PICTURE TAKEN IN TUCK-UNDER PAKRING AREA OF BUILDING A

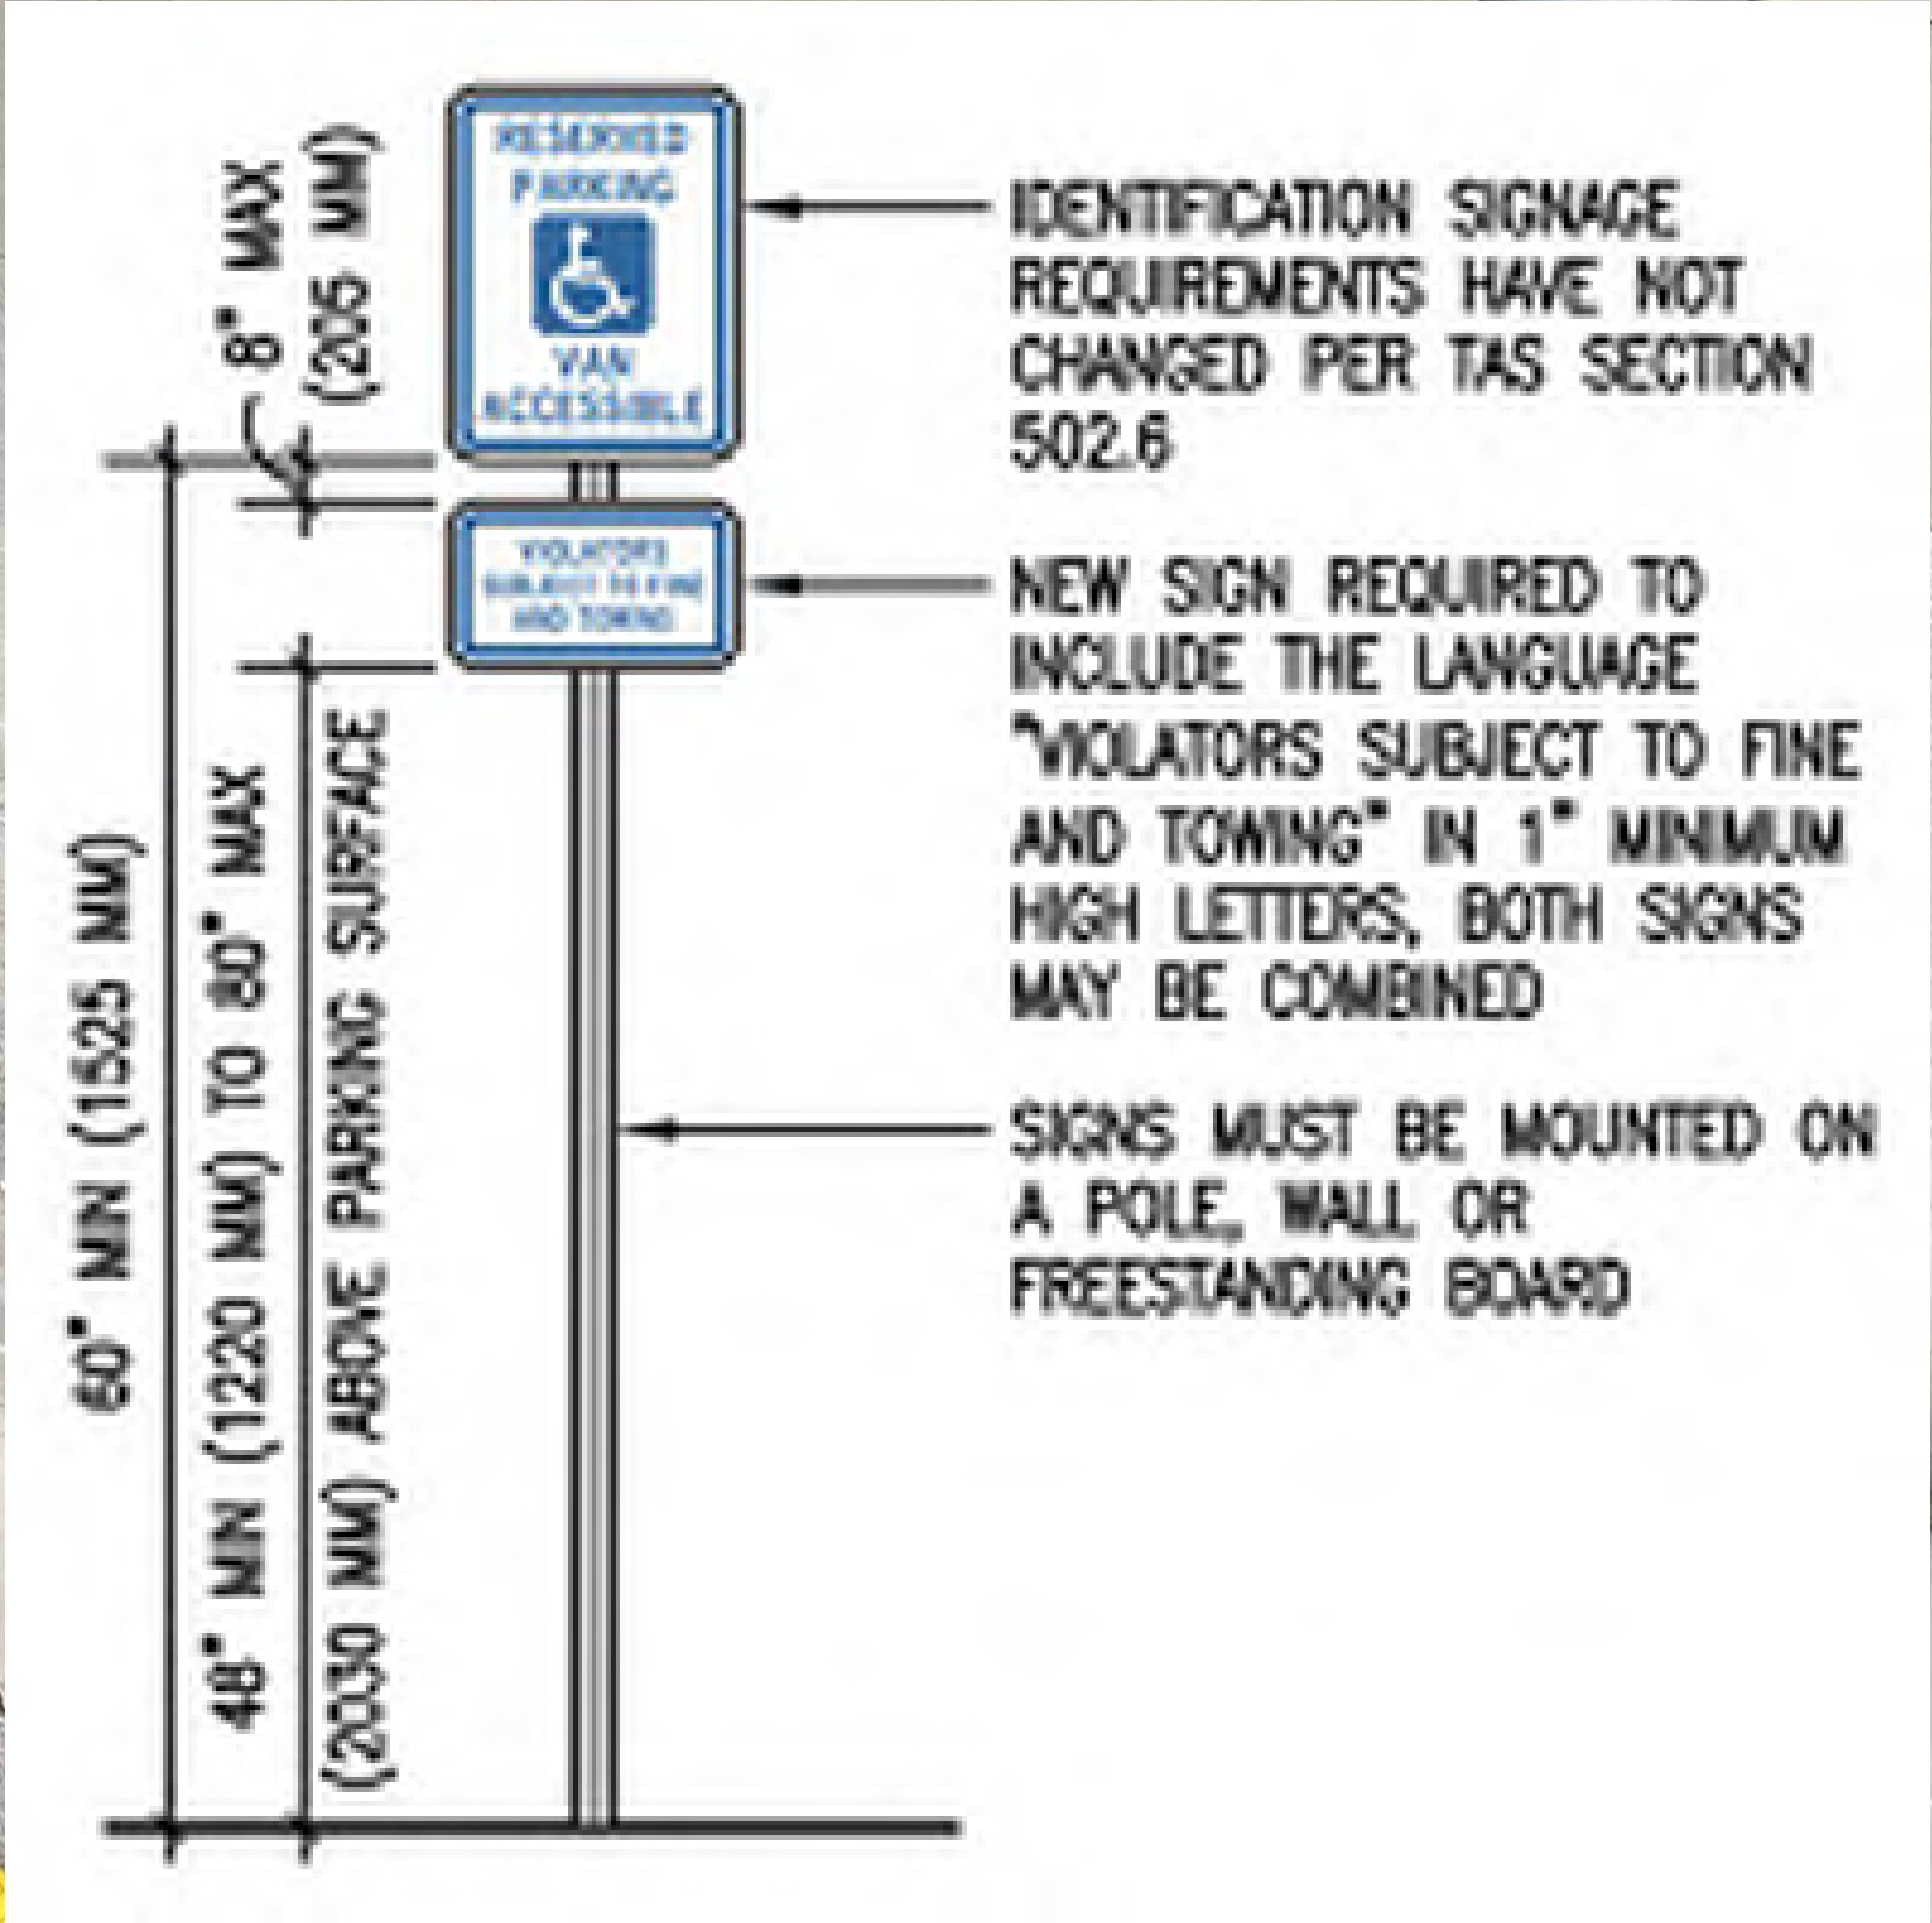
WHY IS THE ADA PARKING SIGN SO HIGH OFF THE GROUND? REDUCE SIGN HEIGHT TO MEET CODE MINIMUM OF 60" AFF SO ITS NOT IN CONFLICT WITH THE FIRE SPRINKLER LINE.
